Union Knitwear Ltd. Union Garments Ltd.

M.C Bazar, Shishu Palli Plus Road, Mulaid, Tengra, Sreepur, Gazipur
(24.24376N, 90.41008E)

15 March 2014

Observations

Ground Floor Plan

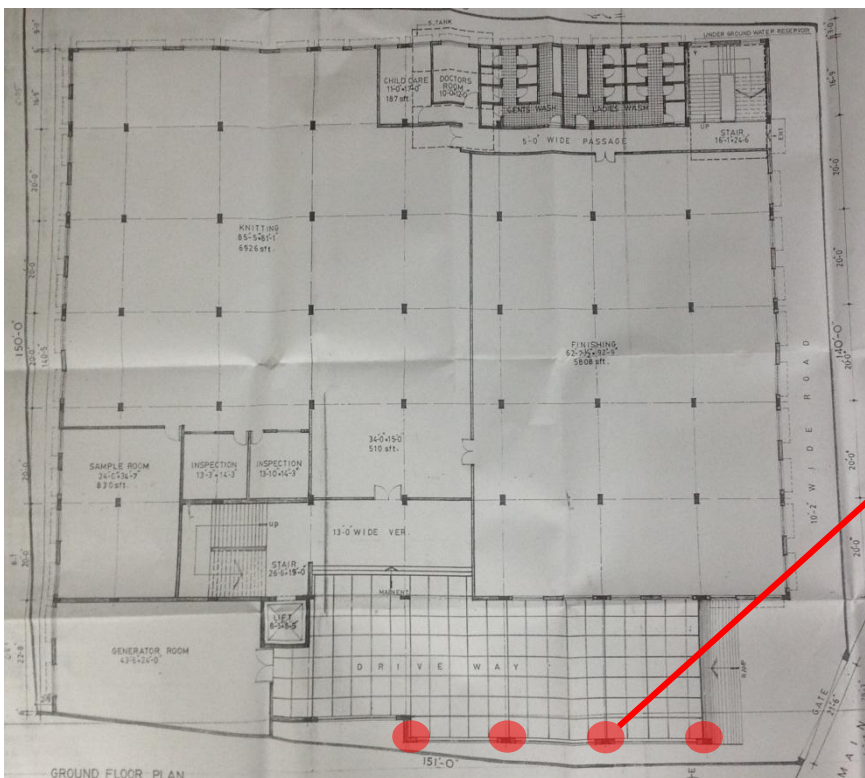
The columns at the front entrance to the building are at risk of being accidentally struck by a vehicle

4 No columns in delivery area at risk of being struck by vehicle.

Building Engineer to check that the columns have been designed for vehicle impact loading or provide adequate protection to the columns at risk of damage due to impact loading.

Typical Column Layout

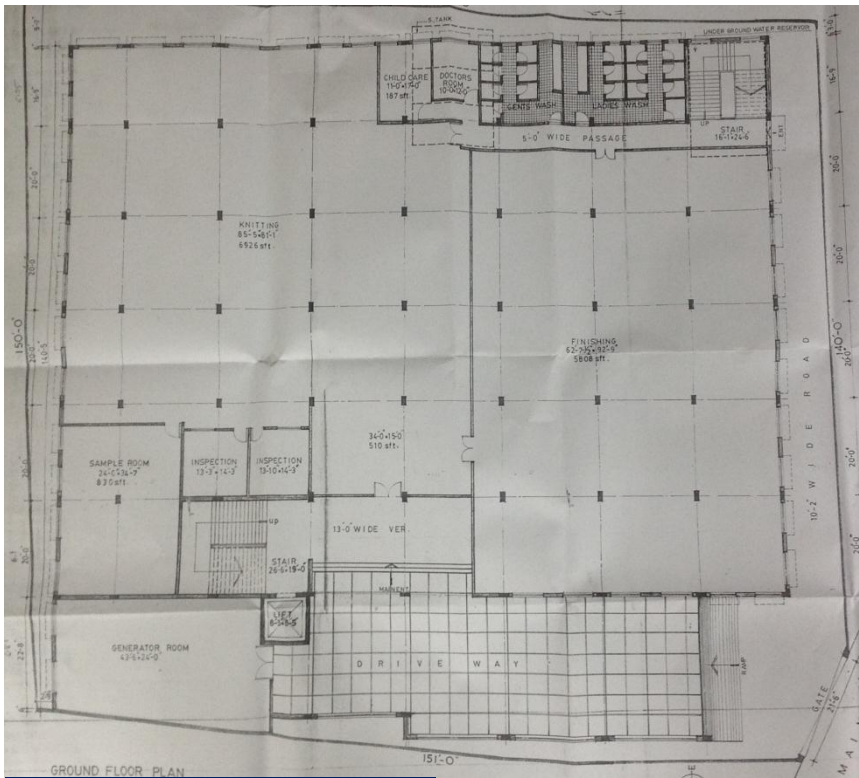
Columns at ground floor appear to be stressed in excess of normal design limits

Cursory calculations indicate that the columns are highly stressed and appear smaller than required by Design Codes for the applied loads.

Building Engineer to verify that columns have been designed to support the applied loads.

Typical Floor Plan

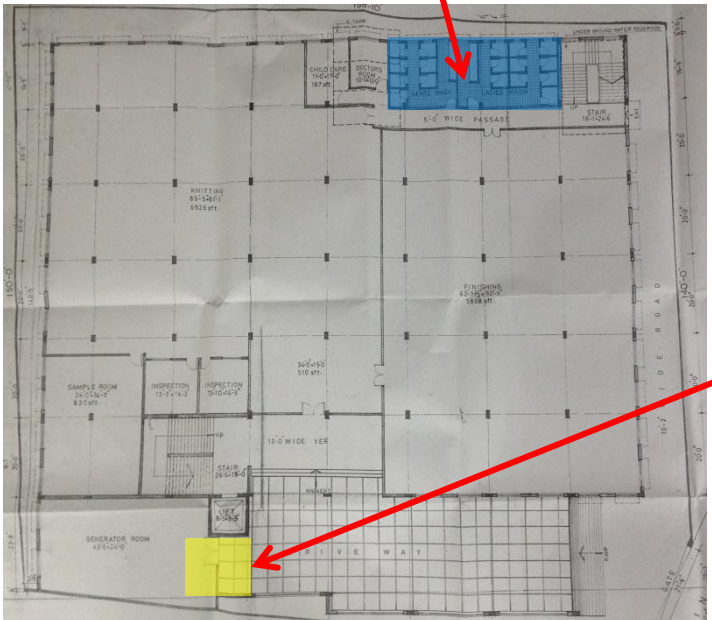
450mm (avg) high floor build-up in toilet area supported by concrete slab and beam arrangement.

Building Engineer to verify that the slab and beams have been adequately designed to carry floor build-up loads

Roof Plan

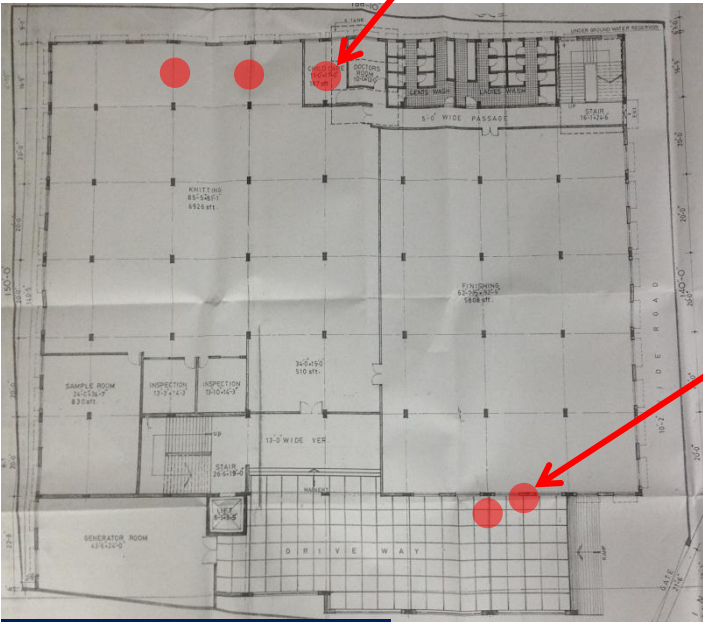
5 No plastic water tanks on 225mm (avg) concrete plinths supported by concrete slab and beam arrangement at roof level.

Building Engineer to verify that the slab and beams have been adequately designed to carry loading due to water tanks

Roof Plan

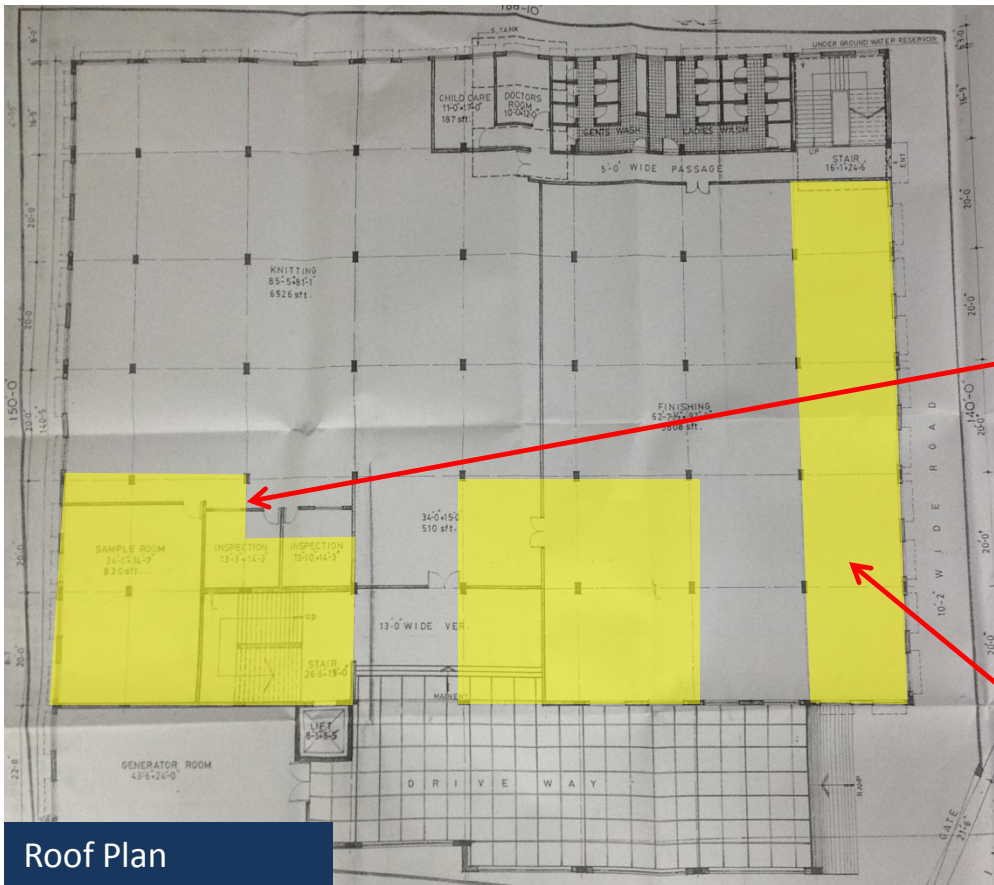
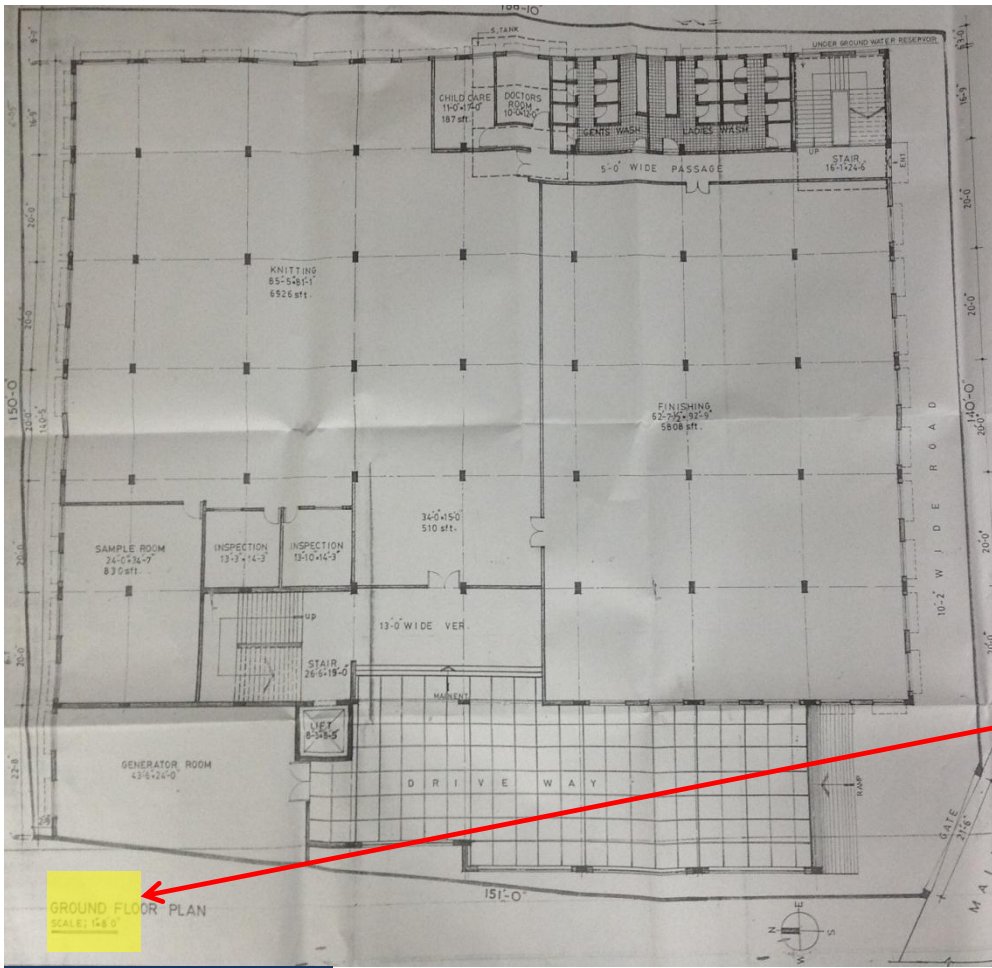
Design check required for the temporary steel structures constructed at 4th Floor Level

Steel framed structures not on permit drawings.
 Building Engineer to verify design of additional steel structure, including stability, and capacity of RC structure to support additional structure.

9	Design check required for the temporary steel structures constructed at 4th Floor Level	Building Engineer to provide detailed calculations for the temporary roof structures and the associated light steel roof. These should confirm their ability to withstand all design wind loadings - pressure, suctions and uplift forces.	6-weeks

Typical Elevation

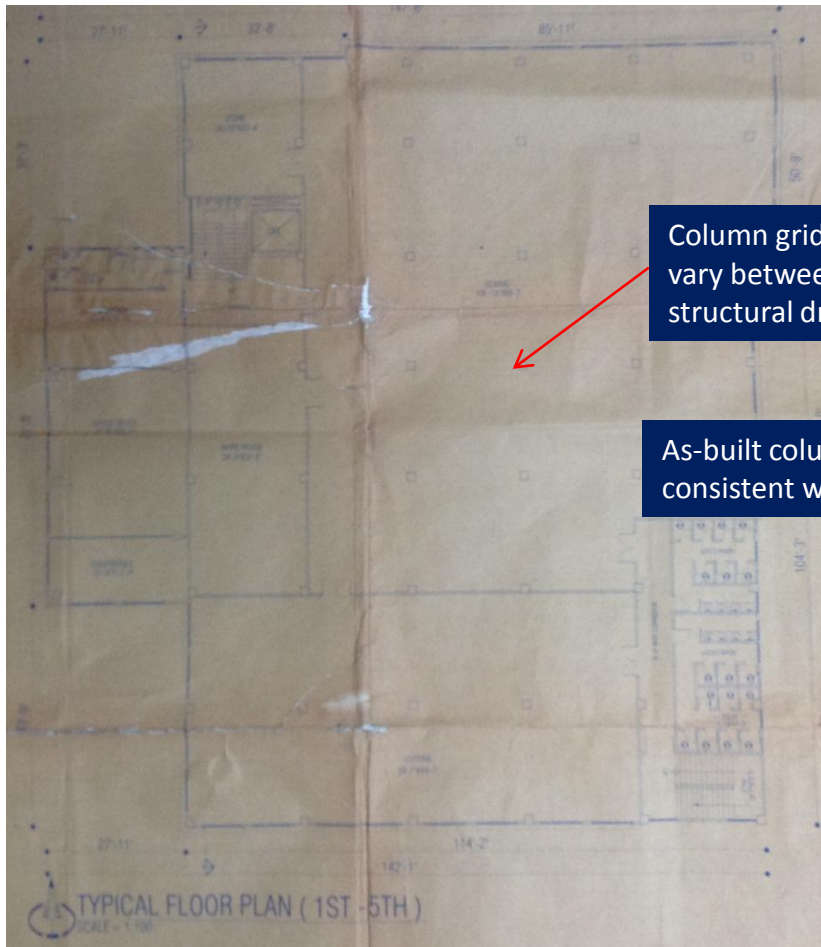
Proposed additional storeys at location shown should be reviewed by the Building Engineer to verify the capacity of the existing support structures.

Structural Drawing – Typical Floor Plan

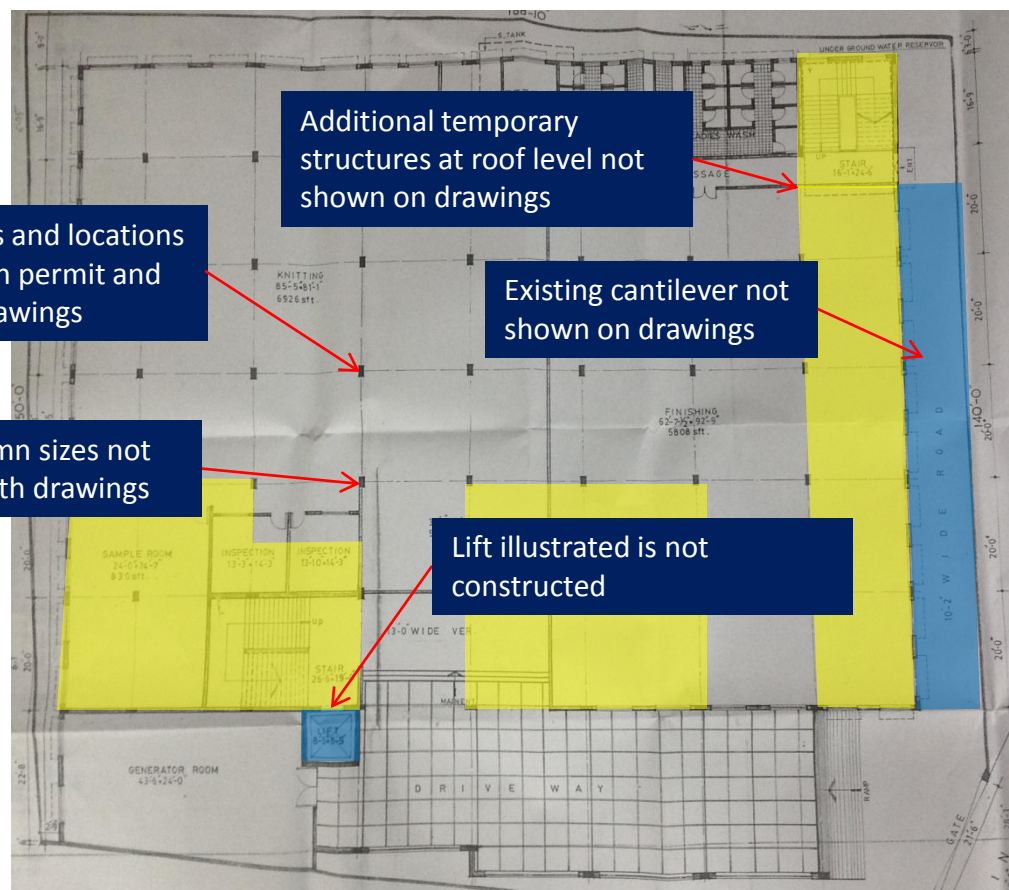
Discrepancies between permit drawings, structural engineers' drawings and as-built structure.

ITEM 7: Inconsistencies between Permit drawings, structural drawings and what is actually constructed. Accurate Structural Drawings should be produced.
